TENNESSEE VALLEY AUTHORITY

Enclosed are ten copies of the Tennessee Valley Authority's response to the Corps of Engineers' questions on the Watts Bar Nuclear Plant application transmitted to us by your letter dated January 27, 1978, to G. Williams, Jr. This transmittal includes TVA responses to questions a through e.

CORPS OF ENGINEERS' QUESTIONS

WATTS BAR NUCLEAR PLANT

Figure a-2

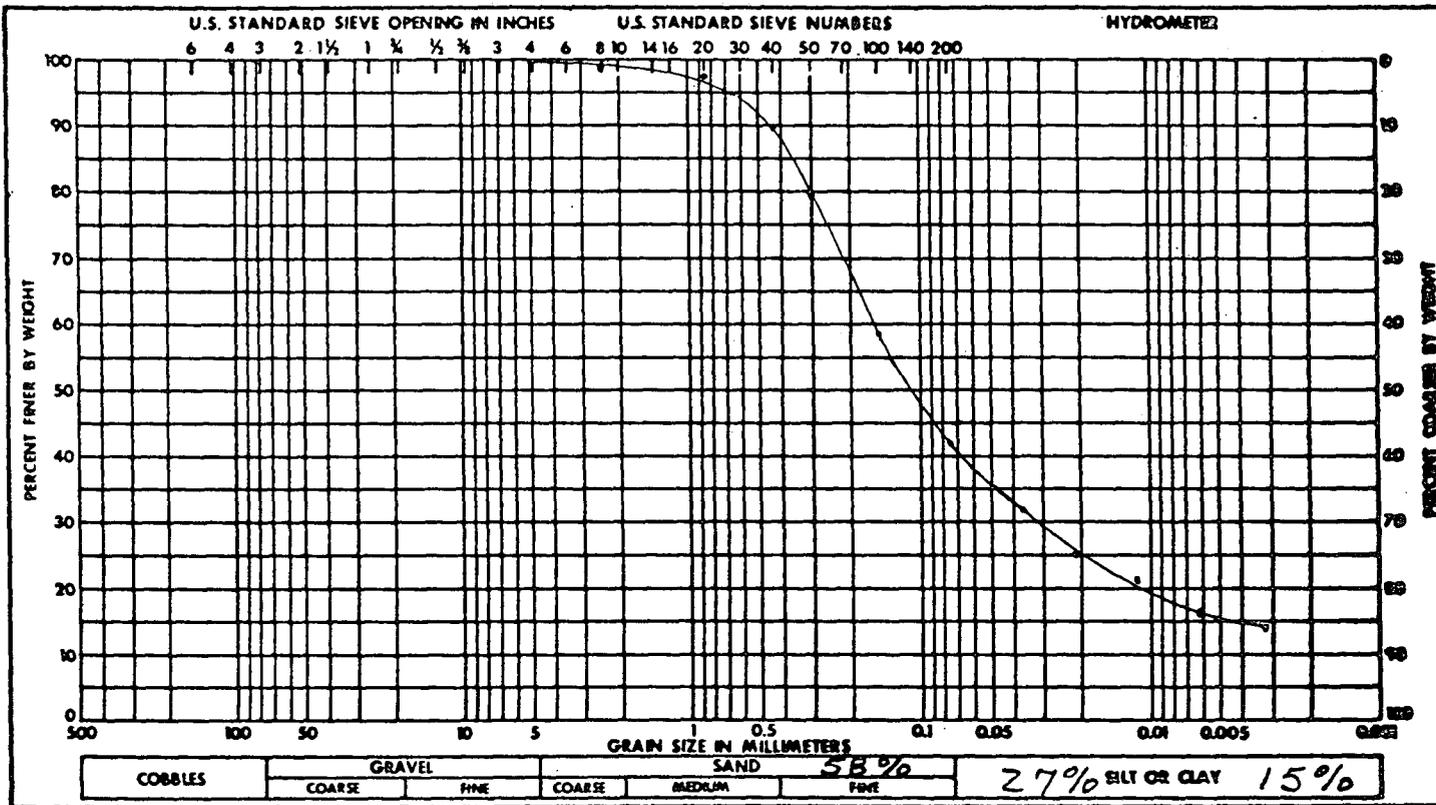
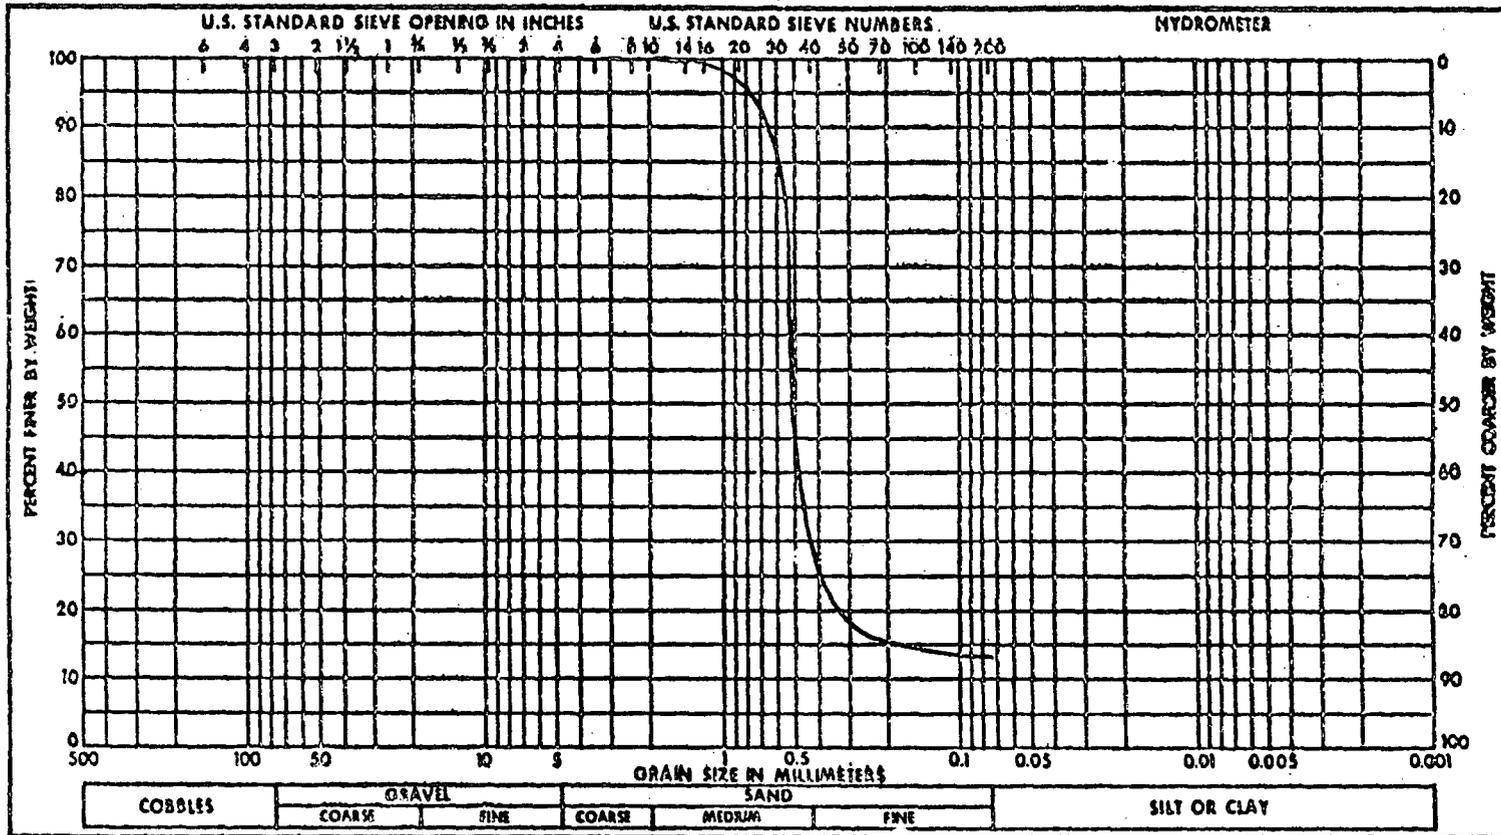
It is our opinion that the investigations of the soil along the alignments of the Class IE conduits and ERCW pipelines, as described in the FSAR, are not adequate to demonstrate that these soils would be stable under seismic loading. Logs of borings on the ERCW pipeline alignment have not yet been received by WES; however, we infer that the information that has been developed is similar to that obtained for the Class IE conduits. Specific reasons for our concern are as follows:

- (2) Nearly total reliance is placed on blow counts and on split-spoon samples to determine soil properties. The few borings in which undisturbed samples were taken penetrated only the upper part of the overburden. Consequently, no direct information is available on the densities of granular soils and their susceptibility to liquefaction. Also, many of the granular soils encountered are described as gravelly; blow counts in such materials are difficult to interpret.

- (3) Reliance is placed on 24-hour water level readings in the split-spoon boreholes to indicate the long-term water table conditions.
- (4) Reliance is placed on gradation of granular soils to provide their nonsusceptibility to liquefaction. It is our opinion that gradation alone is not a sufficient basis to conclude that any cohesionless soils are safe against liquefaction.

Figures a-1 and a-2 are gradation curves for the silty sands found between elevations 714 to 722 in boring SS-92. These figures show the silty sands to be well-graded materials whereas liquefaction is normally associated with uniformly graded materials. In addition, the percentage of silt and clay present in these samples (42 percent) is significantly above the range of 10 percent or less specified in the criteria of Section 2.5.4.8 of the FSAR. A comparison of these

If we use a water-table elevation of 703 in boring SS-92 and allow for a 3-4 feet fluctuation, the SM material between elevations 714 and 722 is typically 10 to 11 feet above the water table and a minimum of approximately 6 to 7 feet above it when long-term fluctuations are considered. Therefore, the SM material in boring SS-92 will normally be in a unsaturated state and cannot liquefy.
